Subject: FW: WD/2021/2198/MAO - Land at Bird in Eye Farm, south of Bird-in-Eye Farm, Uckfield

Land at Bird in Eye Farm
South of Bird in Eye Hill, Uckfield
Surface Water Drainage
Outfall Concept Design

Arboricultural Note - Response to DC Consultation Comments

OUTLINE PLANNING APPLICATION - LAND AT BIRD IN EYE FARM, SOUTH OF BIRD IN EYE HILL, UCKFIELD (LPA REF: WD/2021/2198/MAO)

Date of 1st Issue 18.08.2020	Designed LWD	Drawn LWD	
A3 Scale 1:500	Checked ET	Approved ET	
Drawing Number 48494/2002/SK01		Revision A

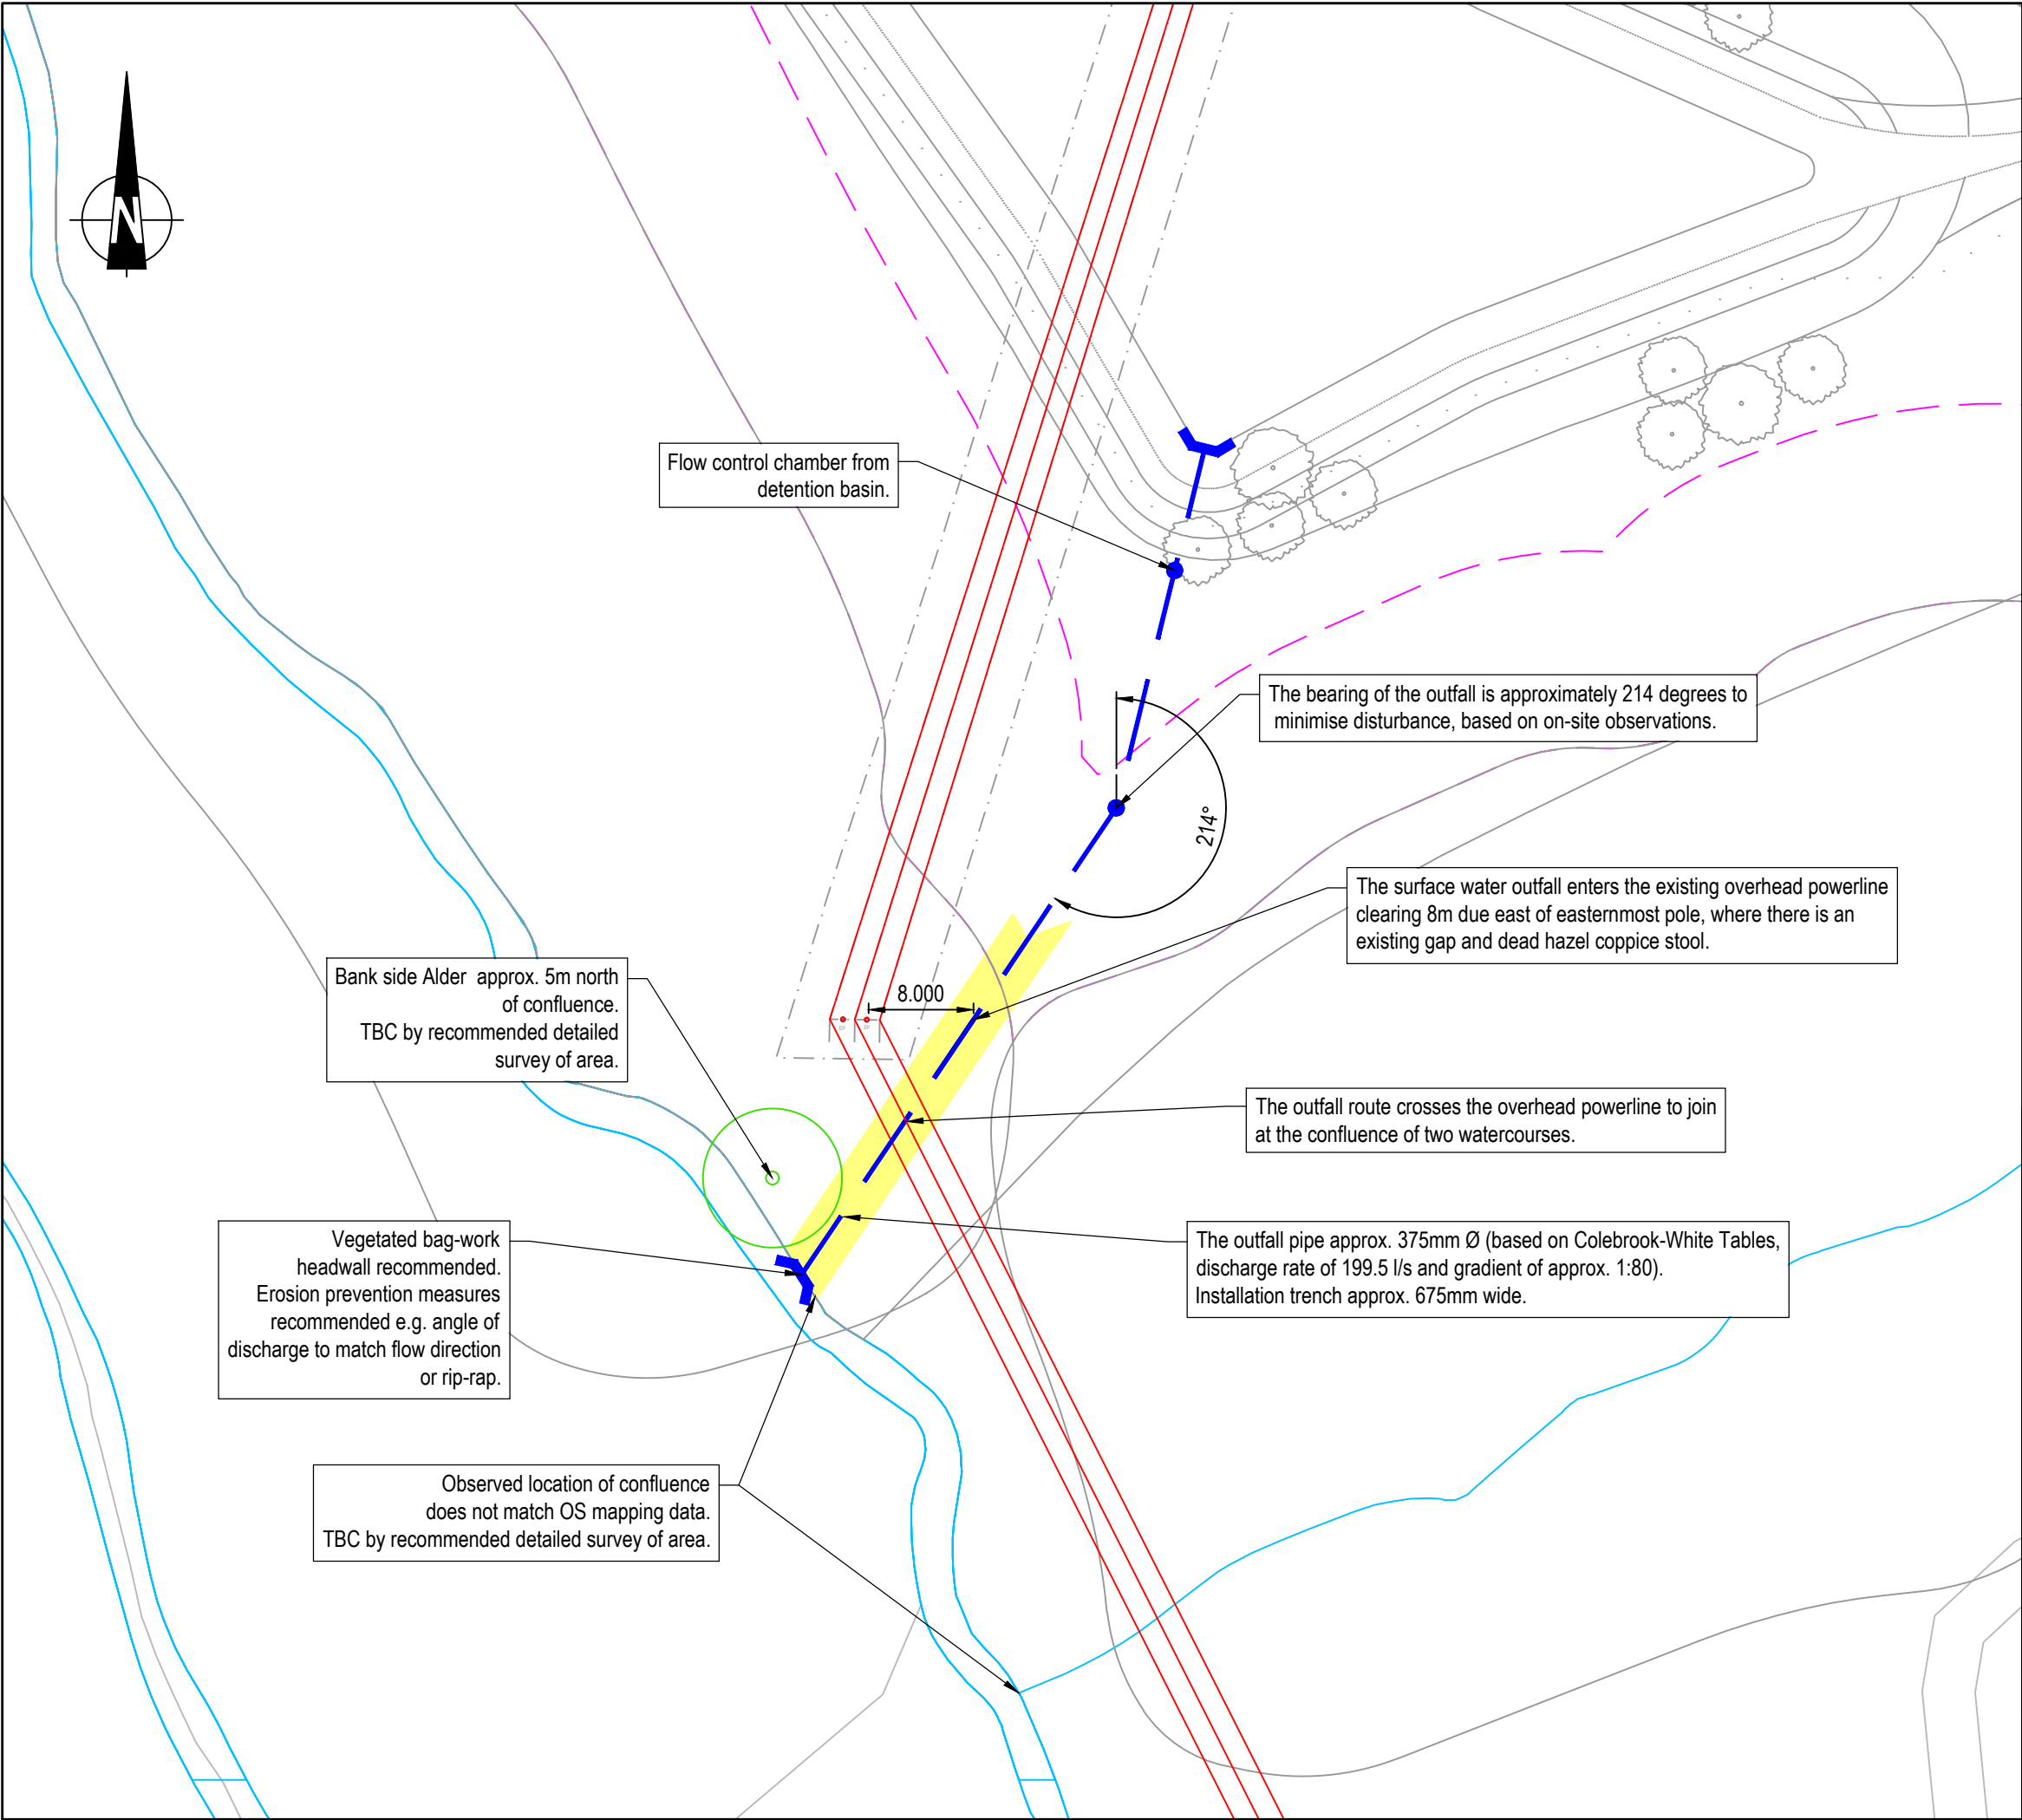
6. A surface water drainage solution is proposed to the south west of the site which would run through the ASNW habitat of Nightingale Shaw. Whilst it is noted that the outfall would be through a cleared/coppiced area and that coppice stools could be translocated, current standing advice states that the current condition of ASNW should not be taken into account when making a decision. The ASNW habitat remains despite the condition or form of the above ground tree population and compensation measures can only be considered where the case meets the 'wholly exceptional' threshold set by the NPPF, the circumstances of this proposal do not meet that threshold (NPPF footnote 63: For example, infrastructure projects (including nationally significant infrastructure projects, orders under the Transport and Works Act and hybrid bills), where the public benefit would clearly outweigh the loss or deterioration of habitat). This would be wholly unacceptable and contrary to both NPPF para 180c and WDC saved policy EN13.

6. It is recommended that final surface water drainage outfall arrangements should be informed by a detailed survey of the area, to accurately locate trees and other vegetation which are to be protected and confirm the depth of the watercourse. This should be undertaken prior to submission of any relevant Reserved Matters Applications.

7. Coppice stools can be retained where not on the outfall alignment. Hazel can be coppiced immediately prior to works and overlain with dense wood chip and ground protection boards. The trench can be excavated between parallel protections boards and backfilled with excavated material.

The surface water drainage outfall has been considered very carefully.

In the location of the proposed outfall is a heavily managed wayleave beneath overhead powerlines. The wayleave has been cleared and the overhead powerlines installed through a section of ancient woodland. The wayleave is not managed for any ecological advantage nor does it consider the ASNW designation. The wayleave is managed, and will continue to be managed on a cyclical basis, in order to safeguard the power infrastructure.

Appropriate mitigation in the form of an appropriate and low impact approach to installation can be provided. This will include, protection of retained trees, ground protection, retention of material from site for reinstatement, the possibility of alternative installation techniques (e.g. trenchless installation).
